Technical Bulletin

SUBJECT: PHILCO I.C.'s

N-Series

3/17/70

PHILCO

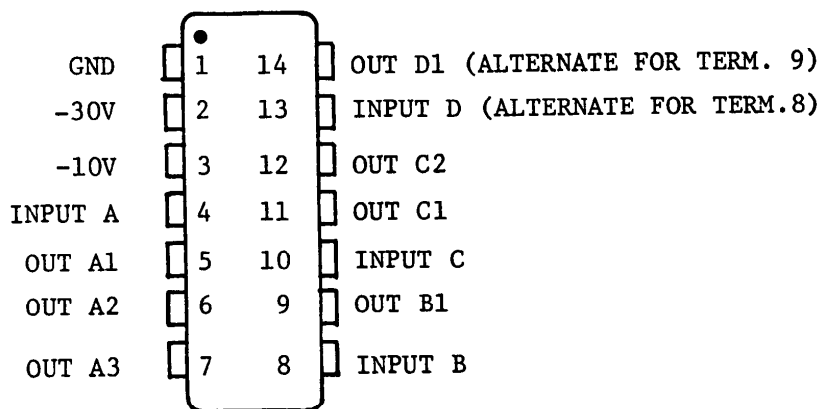
Since that time a second version of the Philco I.C. has been used in production. These are gold color instead of black, and may be used interchangeably with the black ones.

For proper orientation a dot appears in one corner of the top of the I.C.'s. The dot identifies the location of pin 1 (ground), as shown in the illustration below. The gold I.C.'s are not notched. The dot is the only guide.
